**CITY OF FERNDALE
THORNTON ROAD WATER PUMP STATION UPGRADE**

**ADDENDUM NO. 2 (4 pages total)
Issue Date: May 23, 2018**

SHEET: C2.2 OF 18

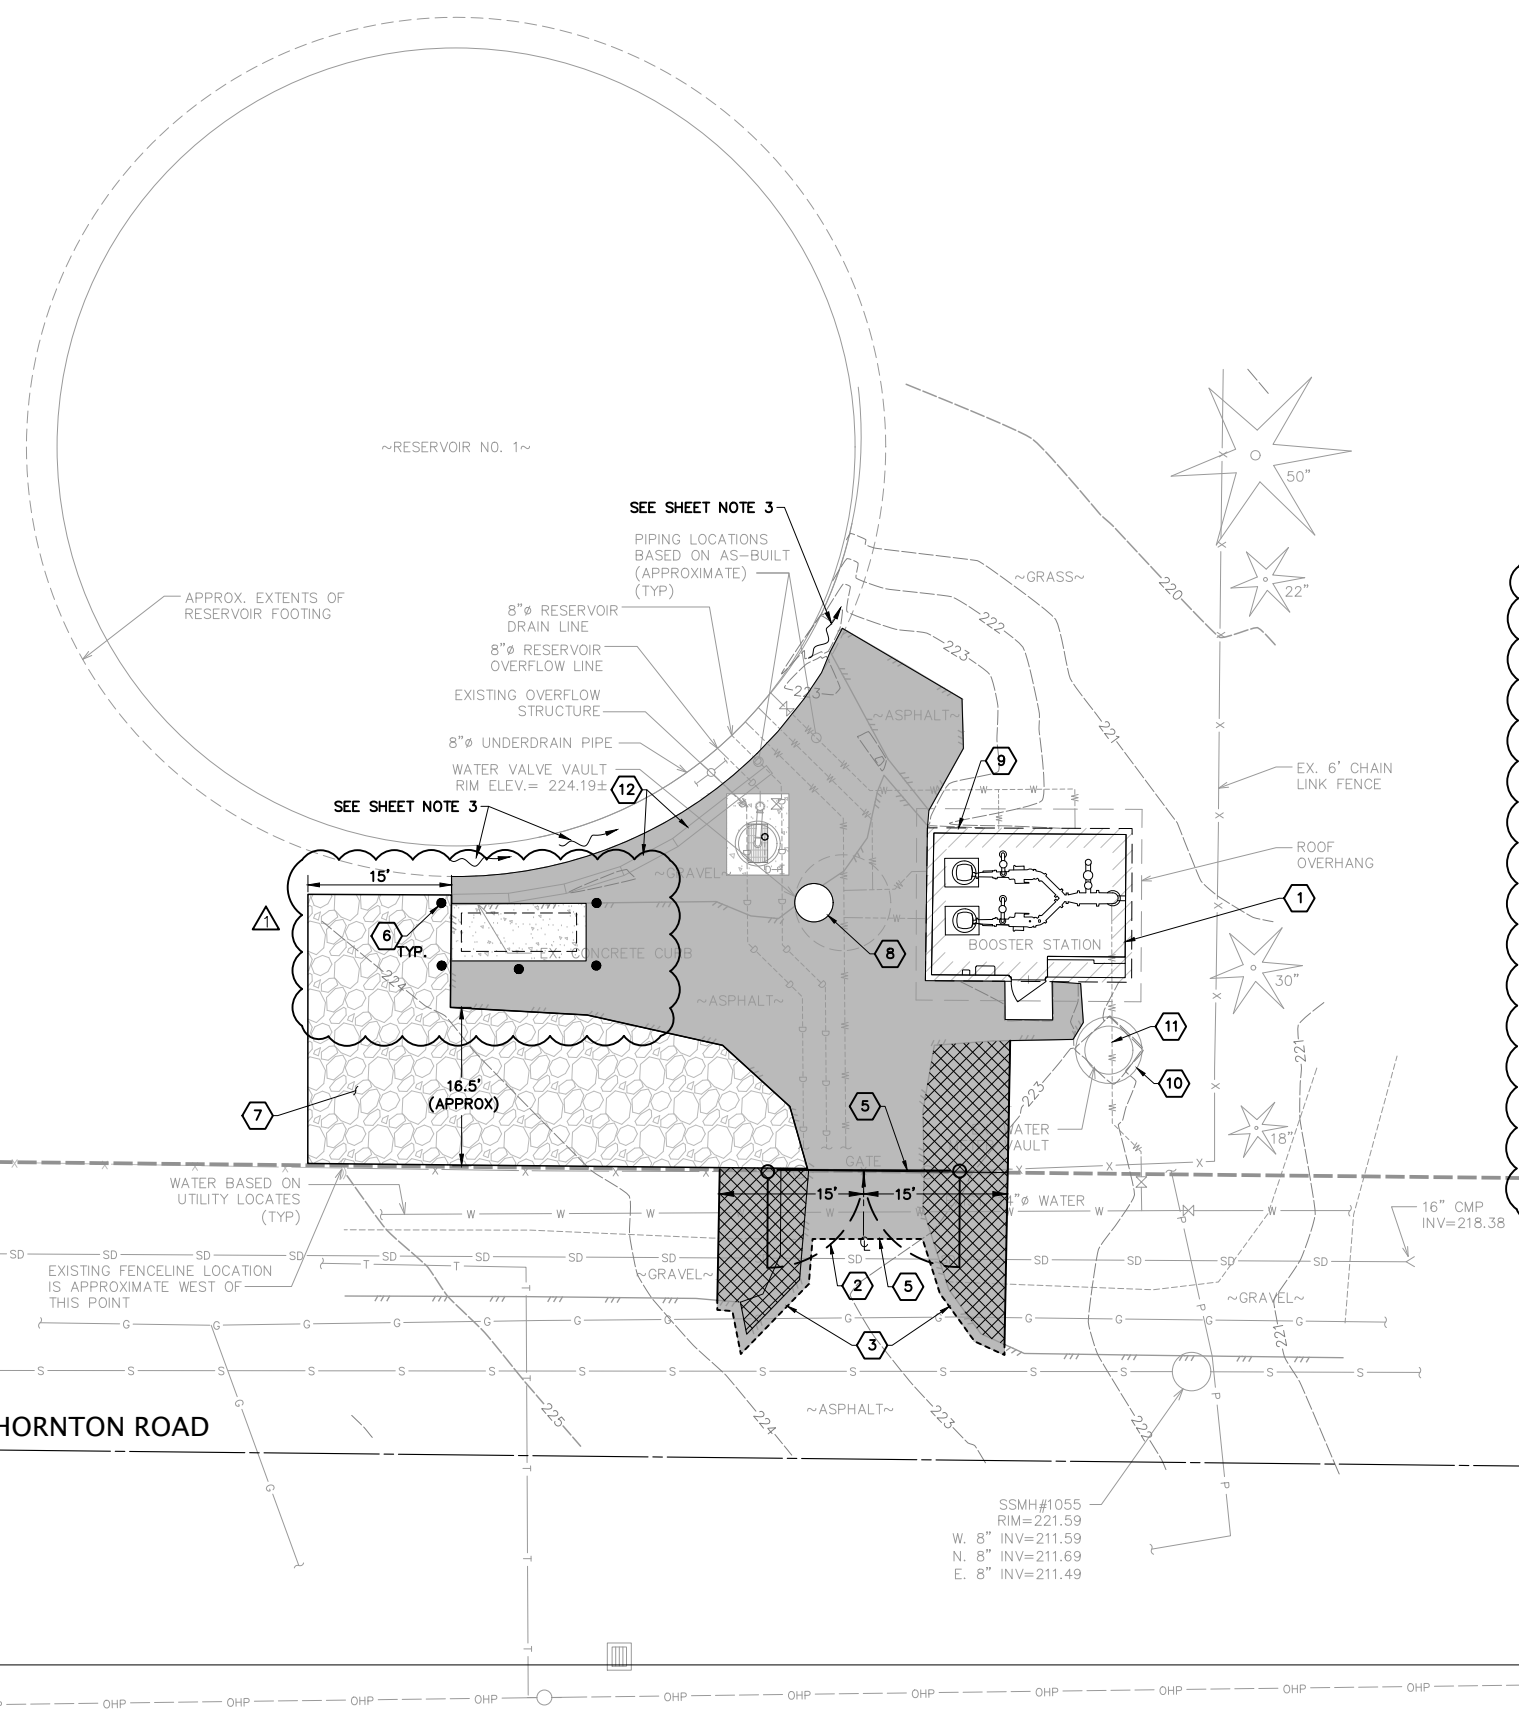
1. Remove and replace existing **PROPOSAL** with the attached (2 pages total).
2. Remove and replace existing **Drawing Sheet C2.2** with the attached (1 page total).
3. The existing City-provided generator set is a Caterpillar model XQ175 diesel generator rated at 175 kW (generator model LC5).
4. Contractor is to provide one package with both MCC and VFD (fully integrated together) from the Control System Integrator.
5. Pump interlock is not required when running on utility power. The City's Programmer (L2 Systems) will program PLC interlock when running on generator power. Contractor shall provide a placard for the City staff to manually lock-out/tag one pump when on generator power. Coordinate placard details and verbiage with the City.

- 1 = PROPOSED BOOSTER STATION ELECTRICAL & CONTROL UPGRADES. SEE ELECTRICAL SHEETS
- 2 = REPLACE EXISTING GATE WITH NEW 18-FT DOUBLE LEAF GATE. CENTER NEW GATE ON EXISTING GATE LOCATION. RELOCATE & RE-TENSION FENCE END POSTS

- 3 = SAWCUT EXISTING PAVEMENT 1-FT BACK FROM EDGE OF EXISTING & PREPARE TO JOIN NEW ASPHALT SECTIONS
- 4 = NOT USED
- 5 = SAWCUT & REMOVE EXISTING PAVEMENT TO JOIN TRANSITION OF 4" HMA OVERLAY. MAX TRANSITION SLOPE 5%. PROVIDE PRE-LEVELING (HMA) OF TRANSITION SUBGRADE AS REQUIRED.

- 6 = BOLLARD (TYP) PER C3.1
 ENSURE FULL OPERATION OF GENERATOR DOOR PANELS.
- 7 = REMOVE 18-IN DEPTH OF EXISTING SOIL AND REPLACE WITH GRAVEL ACCESS SECTION PER B C3.1

- 8 = REMOVE EXISTING 36"Ø (44" O.D.) STEEL LID AND CONCRETE RISER SECTION. INSTALL 48"Ø TOP SLAB PER WSDOT STD PLAN 8-30.90-02 w/ ALUMINUM H-20 ACCESS HATCH 24"x 30", LW PRODUCTS HS-1B OR APPROVED EQUAL, AND 36"Ø RISER(S) AS REQUIRED FOR FINAL GRADE 1" ABOVE HMA OVERLAY. INSTALL NEW LADDER RUNG TO REPLACE EXISTING REMOVED. DAYLIGHT HATCH DRAIN w/ 2"Ø SCH 80 PVC. ENSURE POSITIVE DRAINAGE.

- 9 = REPLACE EXISTING WALL VENT (w/ LOUVER AND MANUAL DAMPER) IN KIND. EXISTING ROUGH OPENING 47 1/4" Lx 8 1/2" H. PROVIDE PROTECTIVE COATING FOR CORROSION RESISTANCE.

- 10 = REMOVE EXISTING METER VAULT TOP SLAB (7' O.D. x 6" T) AND ACCESS LID. INSTALL 8" THICK TOP SLAB (7' O.D.) w/ ALUMINUM H-20 ACCESS HATCH, 36"x 36", LW PRODUCTS HS-3A OR APPROVED EQUAL. INSTALL ALUMINUM LADDER, LADDER BRACKETS, AND ALUMINUM "LADDER-UP" SAFETY POST (BILCO PRODUCTS, OR EQUAL). USE STAINLESS STEEL NUTS/BOLTS/ANCHORS. LADDER SHALL BE CLEAR OF PIPING IN STRUCTURE. LOCATE ACCESS HATCH FOR EASY AND SAFE ACCESS TO LADDER. DAYLIGHT HATCH DRAIN w/ 2"Ø SCH 80 PVC. ENSURE POSITIVE DRAINAGE.

- 11 = REMOVE EXISTING FLOWMETER AND REPLACE. SEE ELECTRICAL DRAWINGS AND SPECS. INSTALL NEW MAGMETER (FL), RESTRAINED FLANGE COUPLING ADAPTER AND DUCTILE IRON SPOOL (FLxPE). USE STAINLESS STEEL NUTS AND BOLTS. PROVIDE EPOXY COATING FOR DUCTILE IRON SPOOL AND FLANGED COUPLING ADAPTER.

- 12 = REMOVE LOOSE CONCRETE CURBS. SLOPE HMA TO GRADE AT 4:1 SLOPE.
